ALERT SERVICE BULLETIN

206L-17-180
3 March 2017

MODEL AFFECTED: 206L-1 and 206L-3

SUBJECT: MAGNETIC BRAKE ASSEMBLY 204-001-376-003,
INSPECTION AND REPAIR OF.

**Figure 1. Magnetic brake assembly.
(204-001-376-003 in Bell 412 directional control shown as an example)**

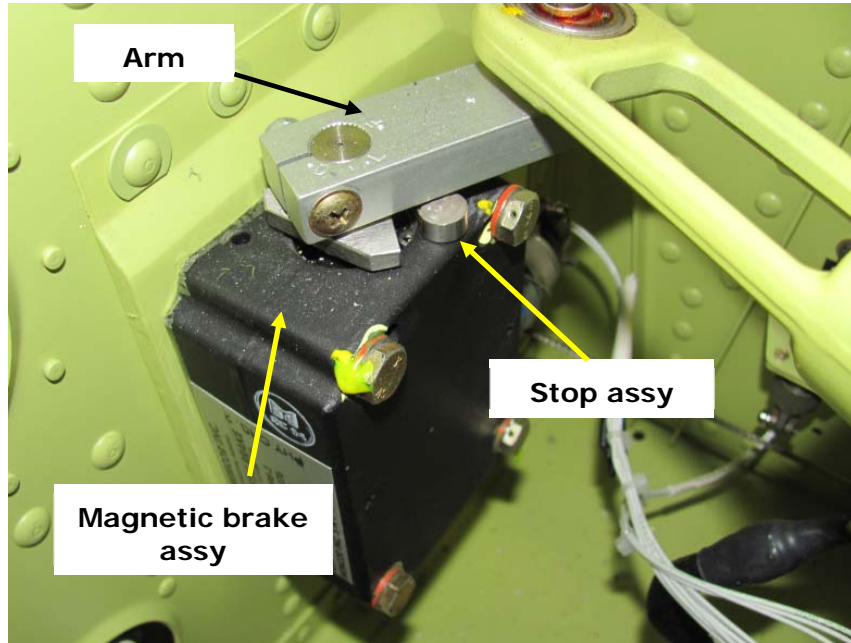
1. Prepare the helicopter for maintenance.
2. Gain access to the fore and aft and lateral magnetic brake assemblies located under the co-pilot seat.
3. Perform a detailed visual inspection of the stop assemblies (Figures 1 and 2). (Figures 3 and 4) show a stop assembly found disbonded.

Figure 2. Magnetic brake assembly with stops properly installed.

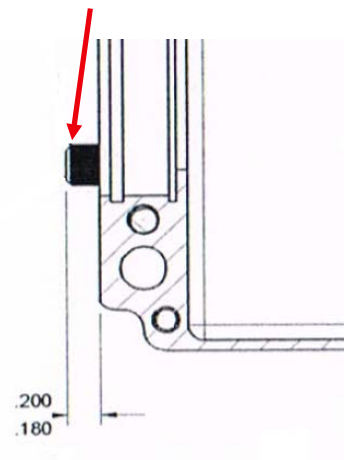
9. The shaft should protrude from the housing surface between 0.180 inch (4.57 mm) and 0.200 inch (5.08 mm). (Figure 2).
10. Allow sufficient time for the adhesive to cure (24 hours at 21° to 35°C (70° to 95°F)) and return the magnetic brake assembly to service. Verify/adjust stop limits to achieve the arm assembly shaft travel. (Figures 5 and 6).

Figure 4. Shaft removed from housing.

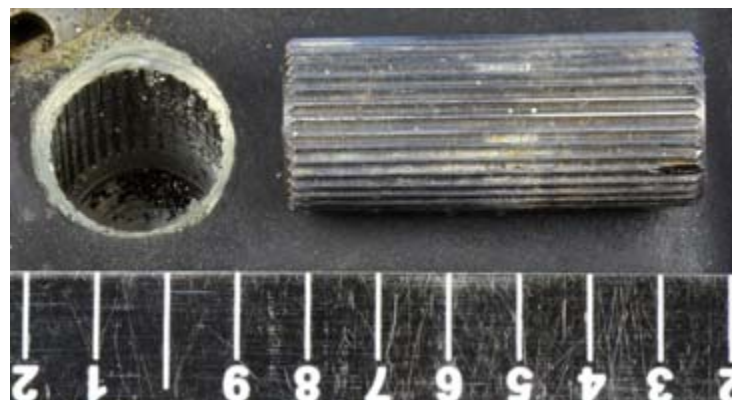
5. Pull out the stop assembly from the housing. (Figure 4)
6. Thoroughly clean adhesive residue from the shaft and the housing bore (BHT-ALL-SPM). If splined stop requires removal from the shaft, index mark the stop, the shaft and the housing to ensure stop installation at the same location. If the screw is removed from the shaft, reinstall with Loctite (C-320) and torque 5 to 10 inch-pounds (0.56 to 1.13 Newton-meters).

7. Apply adhesive (C-317) to the mating surfaces of the housing and the shaft.
8. Install the stop assembly in the housing bore and remove excess adhesive.
